**DATE:** 04.10.2019  
**TO:** ProTrak  
**FROM:** Bill McDow  
 Transportation Planning

■ **TIMBERLYNN VILLAGE CONCEPT [SRB Plan Review]**

↻ Initial Review Note ↻

**BASE INFORMATION:**

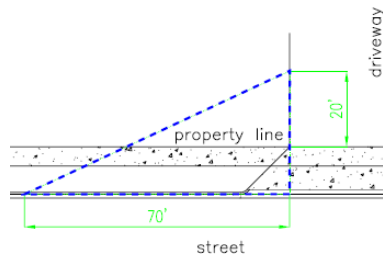
- The proposed plan has multiple plan items on the same sheet. Please revise the plan to show the plan on separate plan sheets. Typical plans have separate sheets for existing condition, demolition, tree inventory, site plan, grading and erosion control and Stormwater management.
